AGENDA
PLANNING COMMISSION MEETING
March 17, 2026
7:00 PM

A. 271 El Camino Real (APNs: 020-406-730, -700, -690, -870, -590, and -790)- Request for an Architectural Review Permit and Vesting Tentative Map to construct a four-story, 64,323-square-foot residential building fronting El Camino Real, consisting of one ground-floor level of parking and three levels of 35 condominium units above. The project also includes a detached two-story, 2,061-square-foot building containing two accessory dwelling units (ADUs) fronting Linden Avenue.

Planning Commission Agenda Item 6.A
Staff Report

A0.2A	BUTLER APARTMENTS 271 EL CAMINO REAL, SAN BRUNO, CA 94066	ELEVATIONS	REVISION: 4TH SUBMITTAL 3 DATE: 4 - 18- 2025

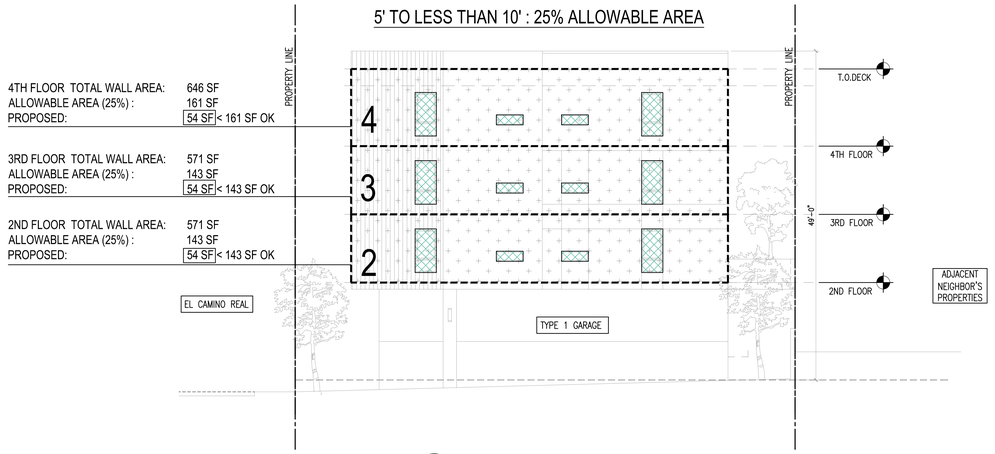
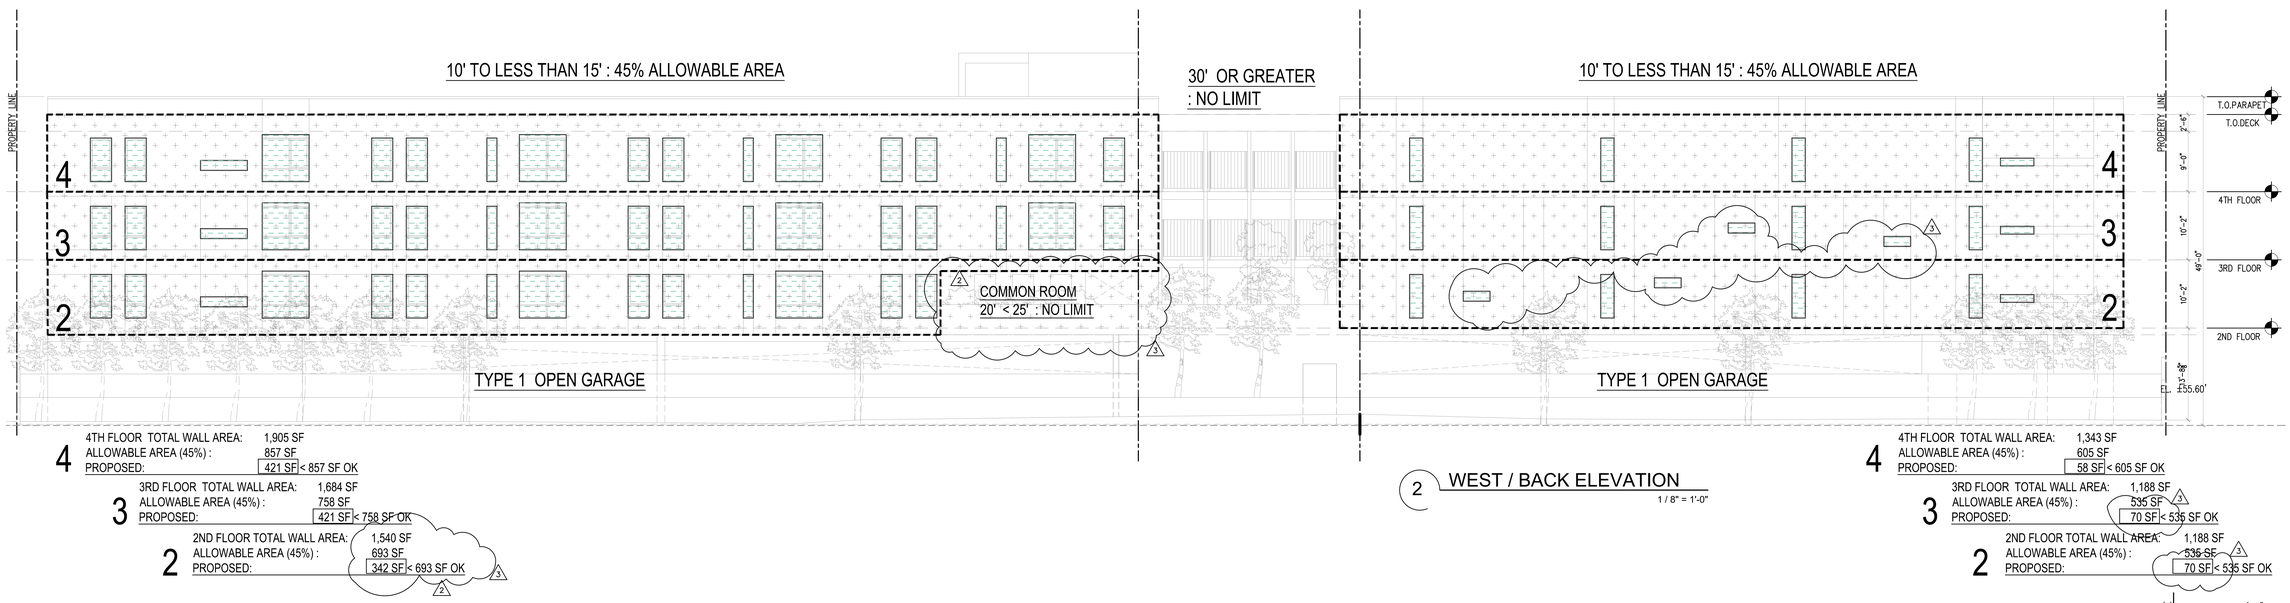
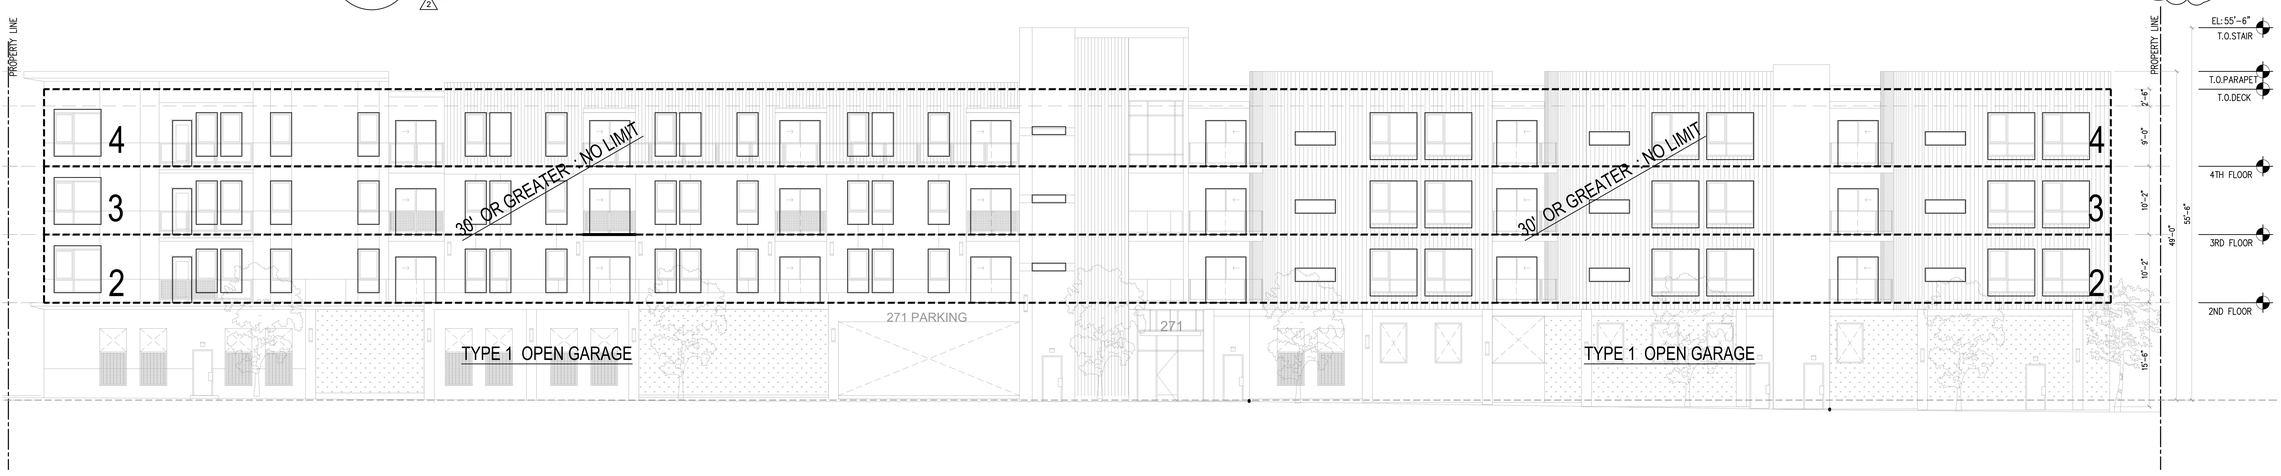
The Planning Commission raised a concern regarding the proposed clear glass used for the street facing balconies, as this would make items stored on the balcony visible from the street. The applicant has since revised the plan to provide opaque glass on the balconies, as reflected in updated sheets A0.1, A0.2A, and A4.0 (Attachment 3).
